Town of Leicester PLANNING BOARD

PLANNING BOARD AGENDA Tuesday, November 2, 2021 @ 7:00PM

TO: Planning Board Members
FROM: Alaa Abusalah, Town Planner
Brooke Hultgren, Planning Department Assistant
DATE: October 28, 2021
RE: **Planning Board Applications – November 2, 2021**

RE: Site Plan Review
#1355 Main Street Energy Storage System (ESS)
ZP Battery Devco, LLC
Map 26/Parcel A1

1.5:1 RIP RAP SLOPE DETAIL
NO SCALE

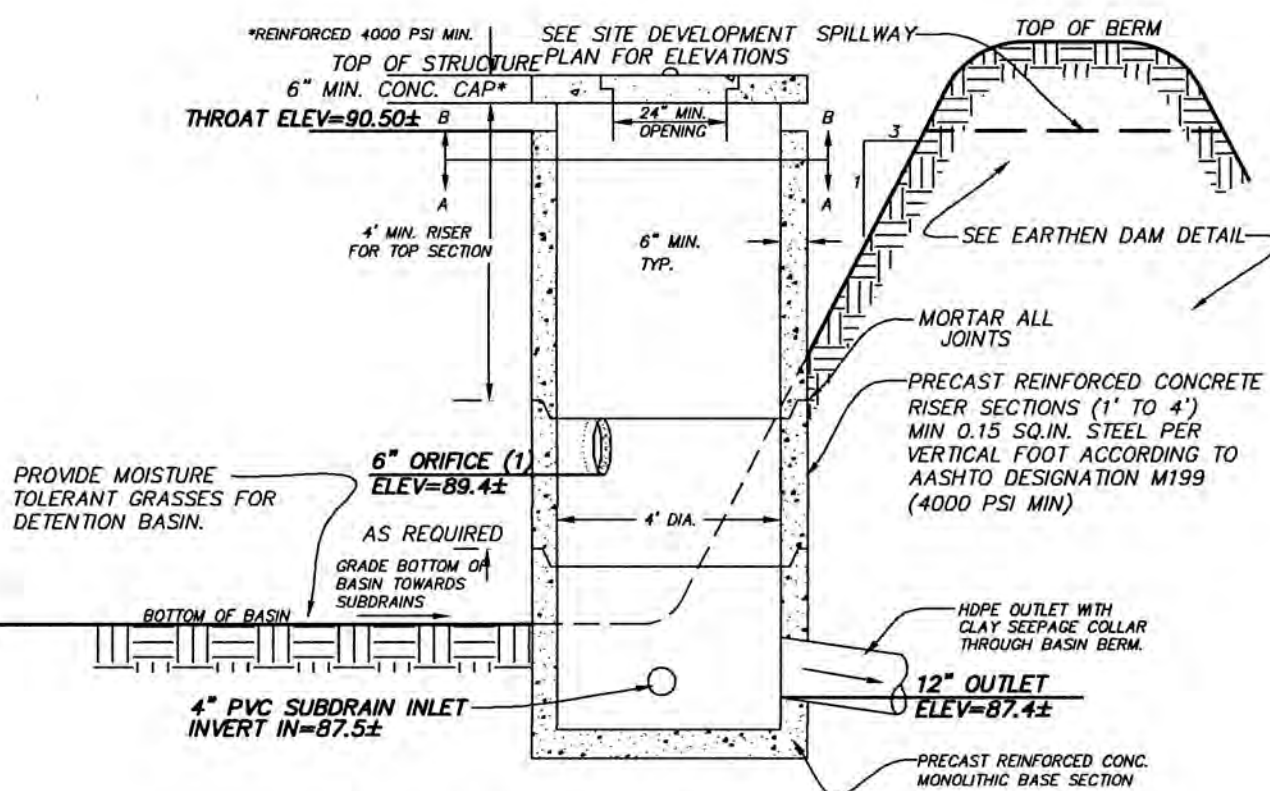
12. A rip rap slope stabilizing detail is referred to on Sheet 3, however, the detail was not found in the plan set. The detail should be provided.
13. The extent of the rip rap slope stabilization called out on Sheet 3 must be depicted on plan.
